**SECTION 75W MODIFICATION
APPLICATION
PUBLIC DOMAIN WORKS, DARLING
WALK, DARLING HARBOUR**

MP 08_0093 (MOD 1)

Modification of Minister's Approval under section 75W
of the *Environmental Planning and Assessment Act*
1979

Figure 3: Proposed realignment of the footbridge (western end of footbridge)

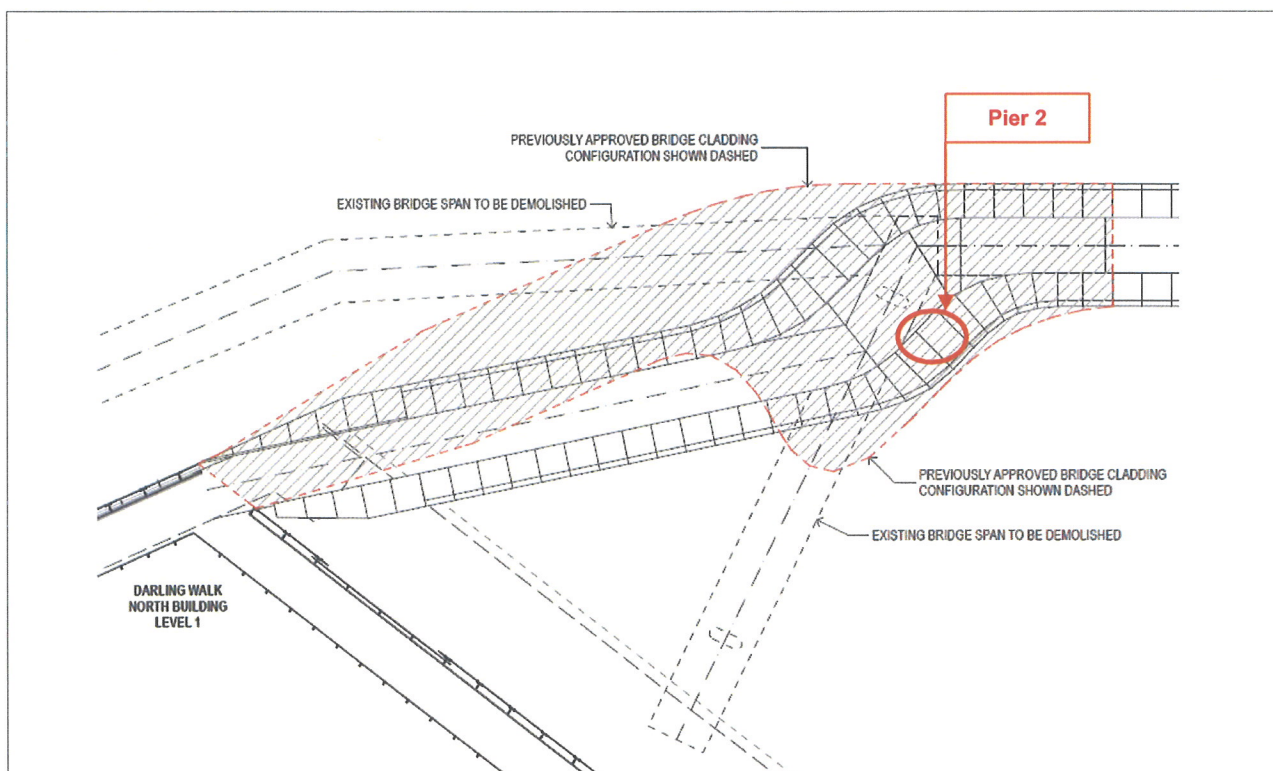
The approved design of the footbridge included a protruding bulging element midway along the footbridge to compensate for demolition of a span that previously connected to the old Sega World building, which provided some structural support for the footbridge (see **Figure 3**). The protruding element required additional concrete weighting to balance and stabilise the bridge. The concrete weighting resulted in a 22% increase in the load on Pier 2 of the bridge. Pier 2 sits above the wall of the Cross City Tunnel (CCT) structure.

Since approval of the footbridge design, CrossCity Motorway Pty Ltd (operators of CCT), has advised that no additional loads could be applied to piers 2 and 3 of the footbridge which are positioned and affixed to the ground above the CCT structure. Lend Lease has revised the design and alignment of the footbridge so no additional loading would be placed on Piers 2 or 3 of the footbridge.

The modified design involves a slight repositioning of the footbridge and the removal of the protruding element midway along the footbridge (see **Figure 3**). This creates a consistent form across the full length of the footbridge, which provides for a more streamlined and visually unobtrusive structure. Accordingly, the Department supports the deletion of the bulged section of the footbridge.

Figure 4: Proposed realignment of the footbridge (eastern end of footbridge)

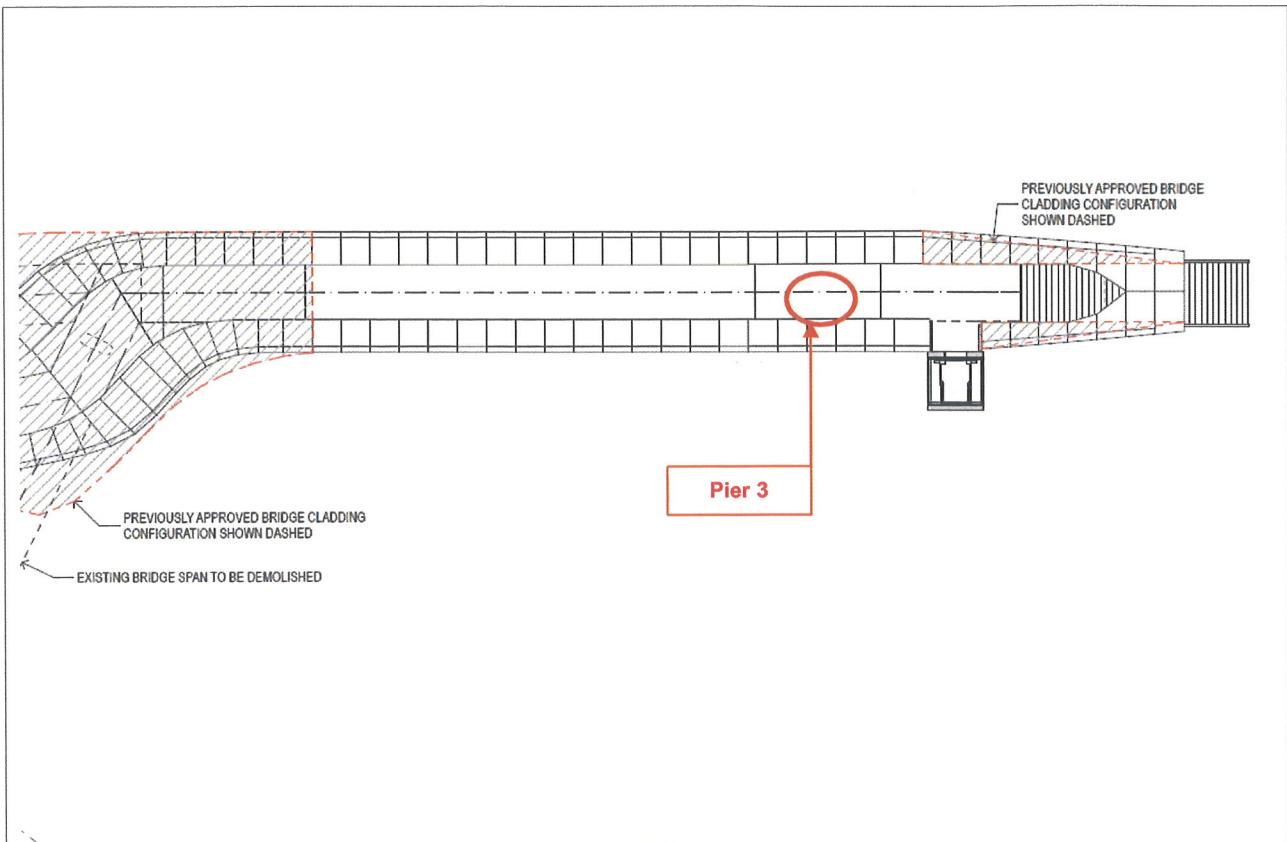
On 29 April 2010, JBA Urban Planning Consultants Pty Ltd, acting on behalf of Lend Lease Development Pty Ltd, submitted a modification application under section 75W of the EP&A Act to modify the approval of the project application (MP 08_0093) to realign and reconfigure the Bathurst Street pedestrian footbridge (note: the application refers to it as the Harbour Street footbridge) and extend the canopy over the stairway at the eastern end of the footbridge (Figures 3, 4 and 5).

The purpose of the modification request stems from removing the footbridge's bulged area as a result of CrossCity Motorway Pty Ltd advising that no additional loads could be applied to piers 2 and 3 of the bridge as they sit above the Cross City Tunnel. The purpose of extending the canopy stems from providing additional weather protection.

Figure 6: Proposed footbridge canopy design, (eastern end of footbridge)

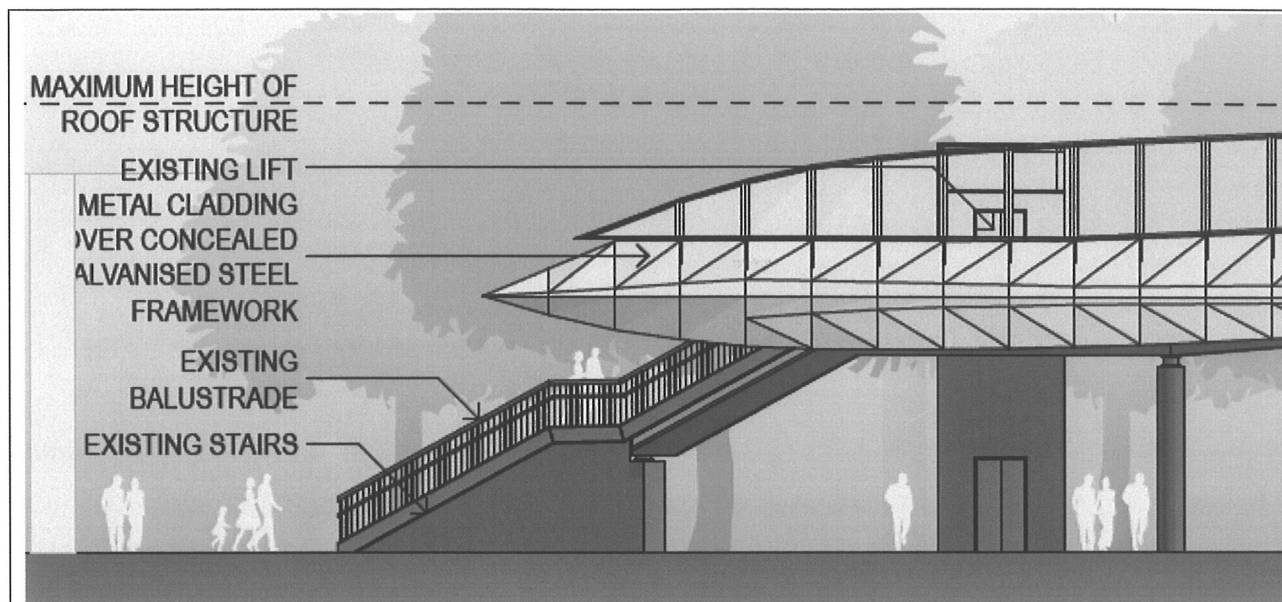
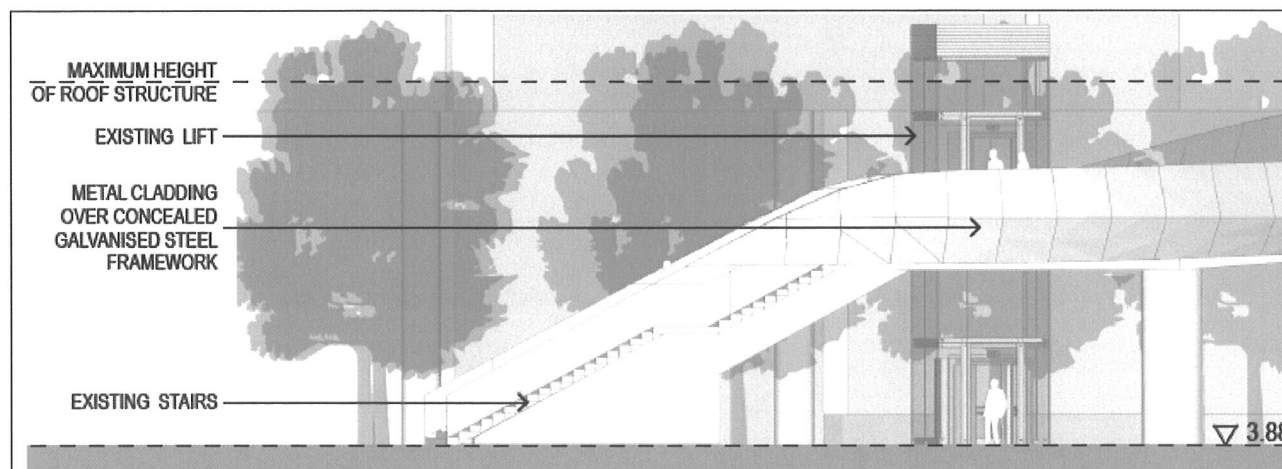
The proposed modification also seeks to extend the footbridge canopy over the stairway at the eastern end of the footbridge (see **Figure 6**). The intention of the proposed canopy design is to provide additional weather protection and to create a more clearly defined entry to Darling

Harbour. The proposed canopy would be a continuation of the approved canopy (**Figure 7**) which covers the full length of the footbridge and constructed of the same materials.

The Department considers that the proposed realignment of the footbridge is required to minimise impacts on the CCT and will have no adverse visual impacts. The proposed extension of the footbridge canopy over the stairway is considered to be an improved entry to Darling Harbour and also will not have any adverse visual impacts.
